INCH-POUND
MIL-H-83511/3
AMENDMENT 1
15 October 1999

HEADSET-MICROPHONE
H-158A/AIC

This amendment forms part of Military Specification Sheet MIL-H-83511/3, dated 04 April 1978, and is approved by all Departments and Agencies of the Department of Defense.

Alternate locking thumbnut configuration.

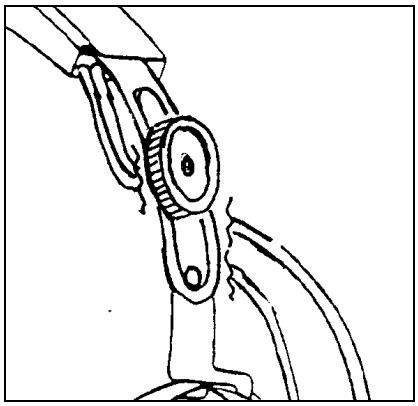
FIGURE 1: Add to Figure 1 Alternate configuration to the sliding action is a positive locking thumbnut.

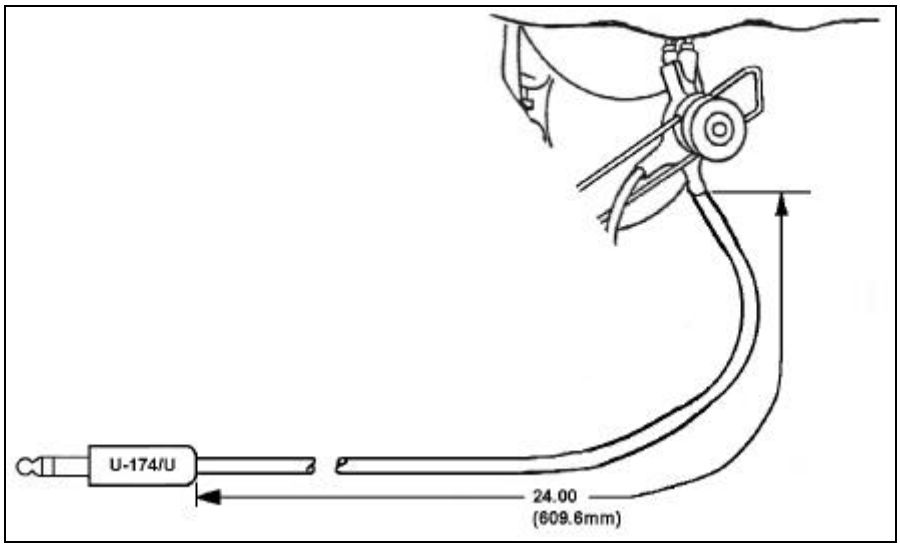
FIGURE 1: Delete the adapter cable and substitute to the main cable assembly as shown:

FIGURE 2. Wiring diagram for H-158A/AIC

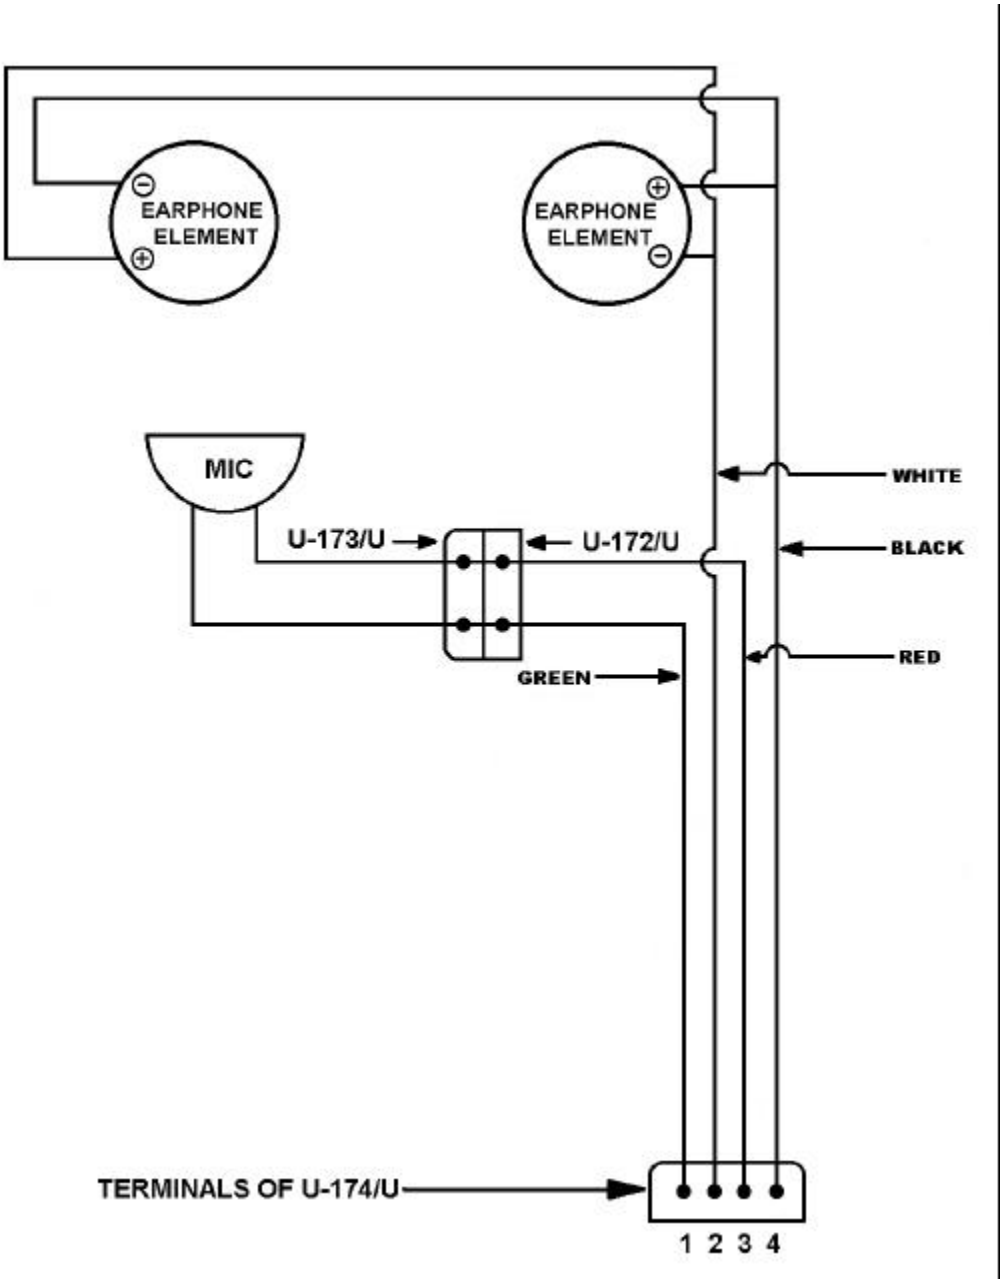
FIGURE 2: Delete and substitute:
